ADDENDUM No. THREE

Date: March 30, 2026
Project: Flemington 2025 LMIG, MES No. 2025-10
Engineer: M.E. Sack Engineering CH
Hinesville, Georgia

C5

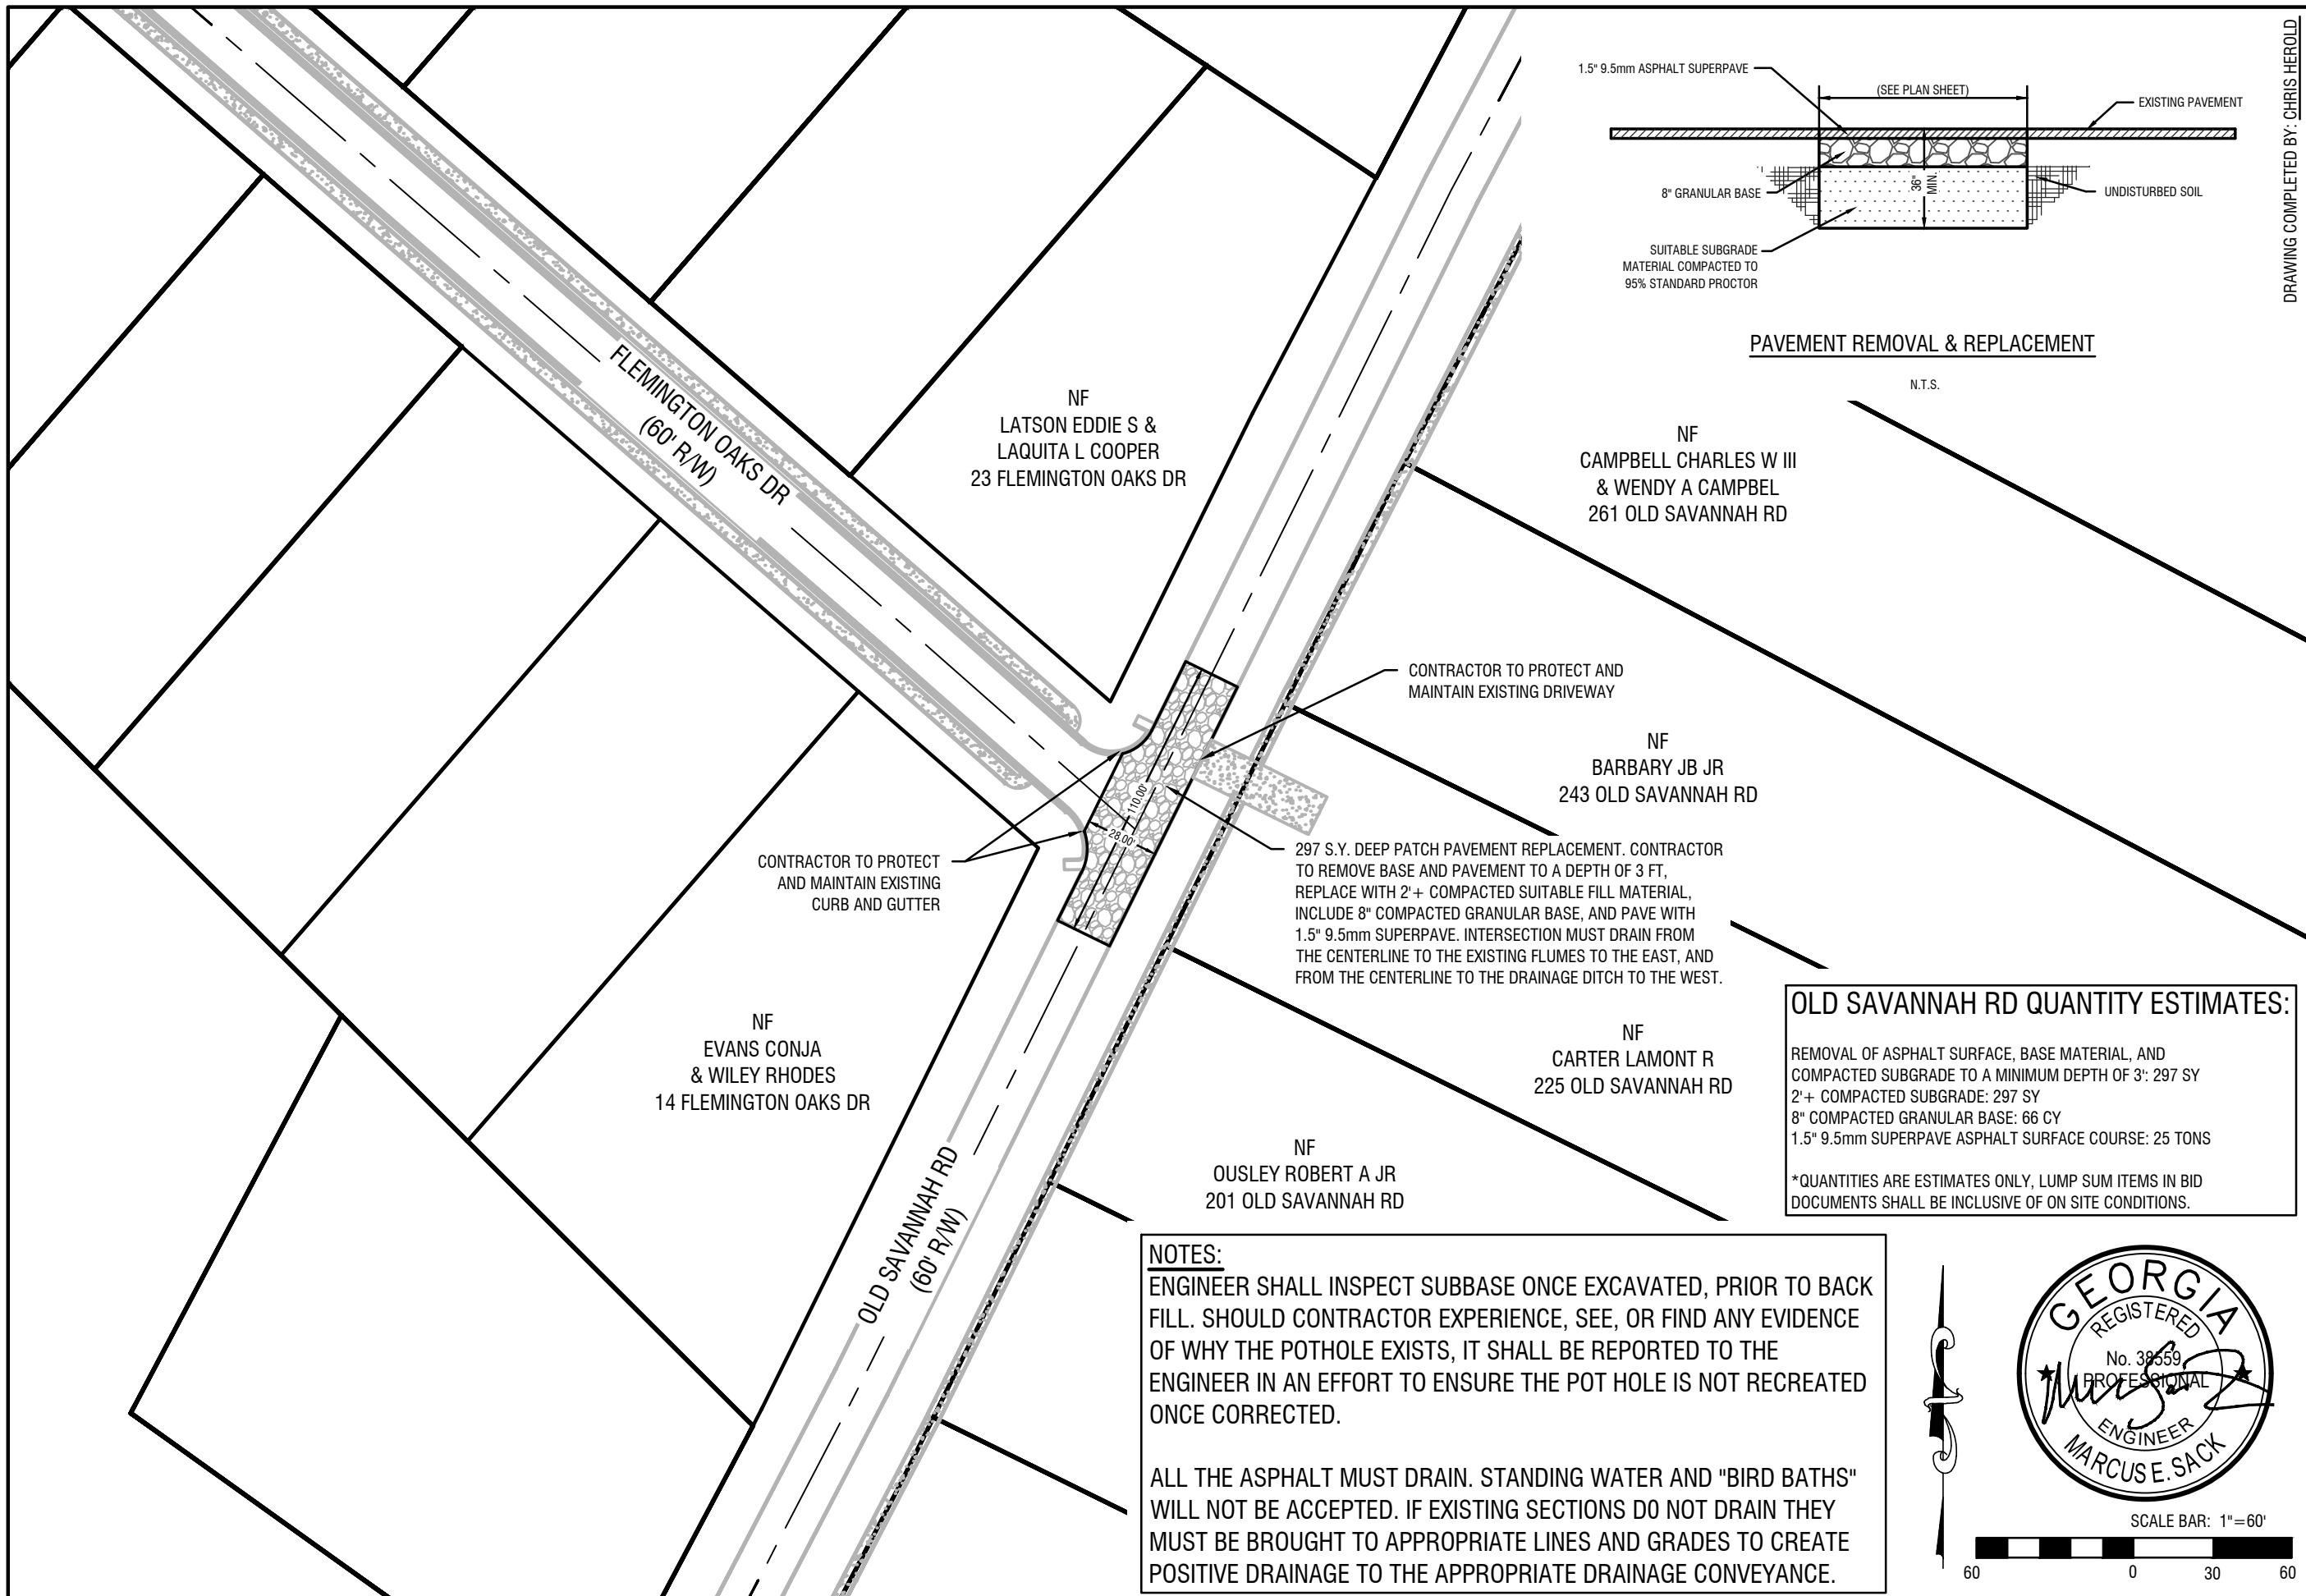
- Replace the plan set with the enclosed of the same. Note that revisions were made to reflect the appropriate quantities and dimensions for patches on E. Cobblestone Lane. The title block was also updated.

- 1) *For E. Cobblestone Lane, the bid schedule indicates 5 SY to be removed and replaced, however the plans appear to show two areas totaling 11 SY. Please confirm the correct quantity.*
 - The notes on plan sheet C5 have been updated to reflect the proper quantities and dimensions of the patches. Five (5) SY is the correct area, and the asphalt surface course was increased to 0.4 tons to cover additional area one (1) foot beyond the potholes.

2) *Due to the limited size of these areas, achieving proper compaction may be difficult. Would the use of 5000 PSI high early concrete with a 2" overlay be acceptable?*

- The engineer will agree to a 5,000 PSI concrete base layer with a 5" thickness, provided the contractor maintains the 3 foot excavation depth, and backfills with the appropriate amount of suitable material to ensure the surface course asphalt will match existing grades and elevations. Please maintain the 1.5" 9.5mm Superpave surface layer.

REMOVAL OF ASPHALT SURFACE, BASE MATERIAL, AND COMPACTED SUBGRADE TO A MINIMUM DEPTH OF 3": 5 SY
 2"+ COMPACTED SUBGRADE: 5 SY
 8" COMPACTED GRANULAR BASE: 1 CY
ALTERNATE 5" HIGH EARLY CONCRETE BASE (5,000 PSI): 0.65 CY
 1.5" 9.5mm SUPERPAVE ASPHALT SURFACE COURSE: 0.4 TONS
